U.S. Department of the Interior BUREAU OF LAND MANAGEMENT Sundry Print Repor

Well Name: AXI APACHE A Well Location: T23N / R5W / SEC 10 / County or Parish/State: RIO

**Sundry ID: 2653802**

Type of Submission: Notice of Intent Type of Action: Plug and Abandonment

# **Current Wellbore Diagram DJR Operating, LLC** AXI Apache A 9

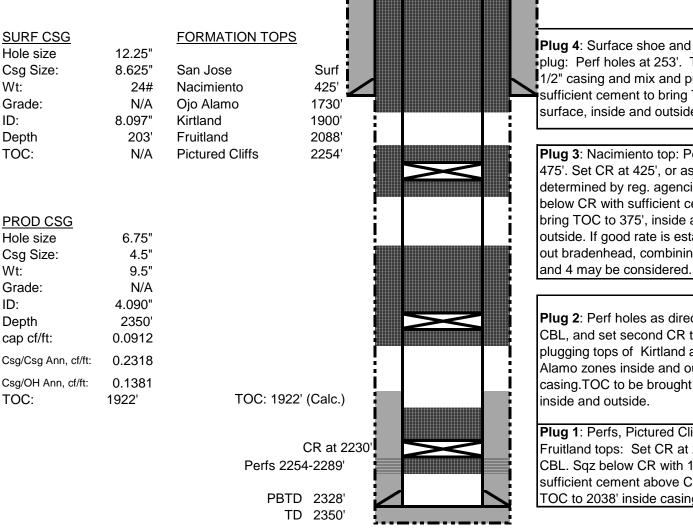
You are also required to place cement excesses per 4.2 and 4.4 of the attached General Requirements.

- The plugs proposed in the P&A procedure will adequately protect any freshwater sands in this well bore.
- No raster logs to pick depths. Went with the operator tops. Appropriate for this area.
- Pictured Cliffs perfs 2254' 2289'.
